CT7-2E INCREMENTAL CHANGE

Release Notification Date: 08/13/2021

MM 72-60-00

ACCESSORY SECTION MODULE - INSPECTION

Figure 602 (Sheet 2) Particle Separator Blower - Inspection

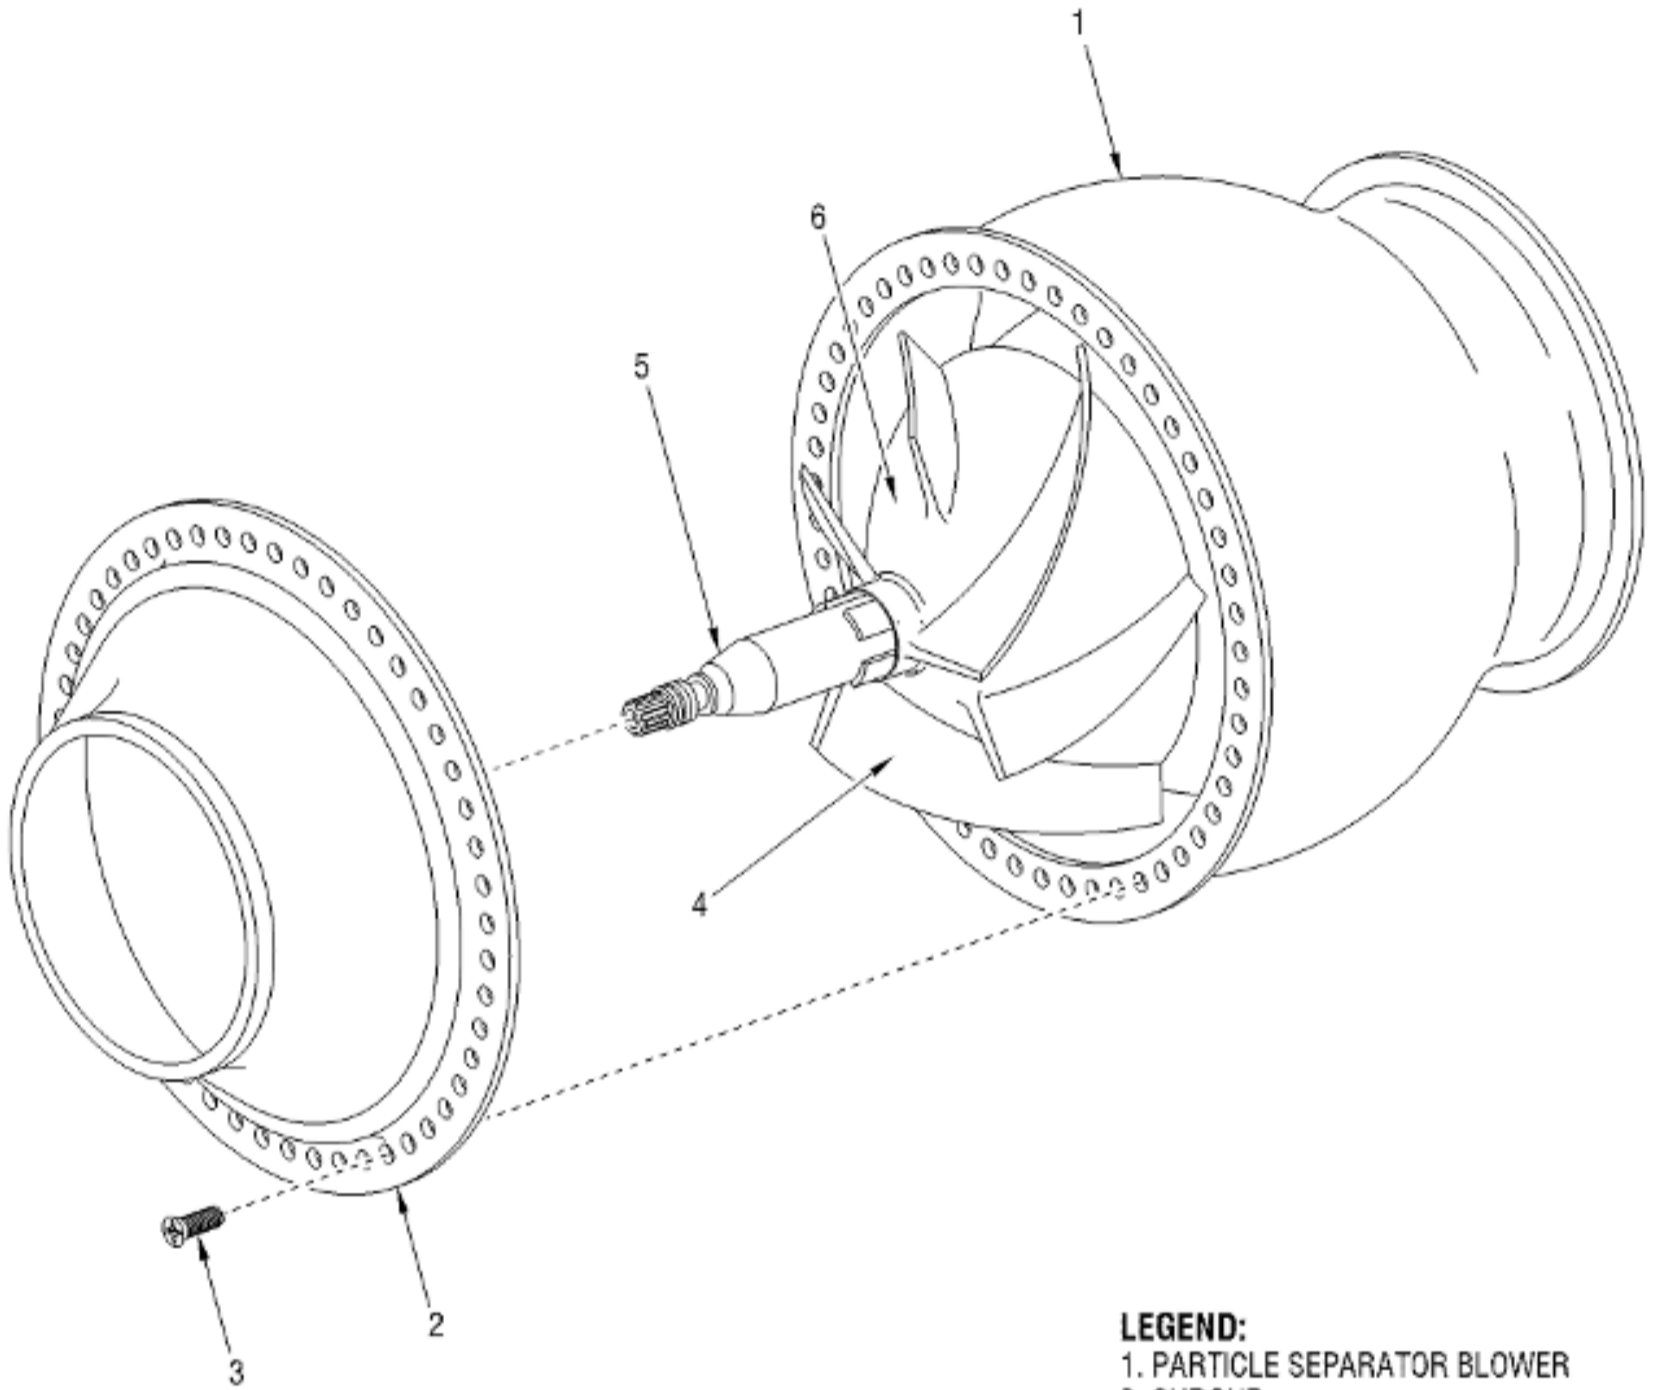
<u>HIGHLIGHT REFERENCE</u>	<u>DESCRIPTION OF CHANGE</u>
tk72-60-00-200-801	Technical Change: Changed the WARNINGS throughout the pageblock to update to the latest format and added metric equivalents throughout the pageblock where applicable.
tk72-60-00-200-801	Technical Change: Changed inspection of the particle separator blower in Table 602 and Figure 602 to add data for CT7-2E1 modified to SB 72-0023.

(1) Remove 51 screws (3, Figure 602, sheet 2) that secure the shroud (2) to the particle separator blower.

(2) Install 51 screws (3, Figure 602, sheet 2) to secure the shroud (2).
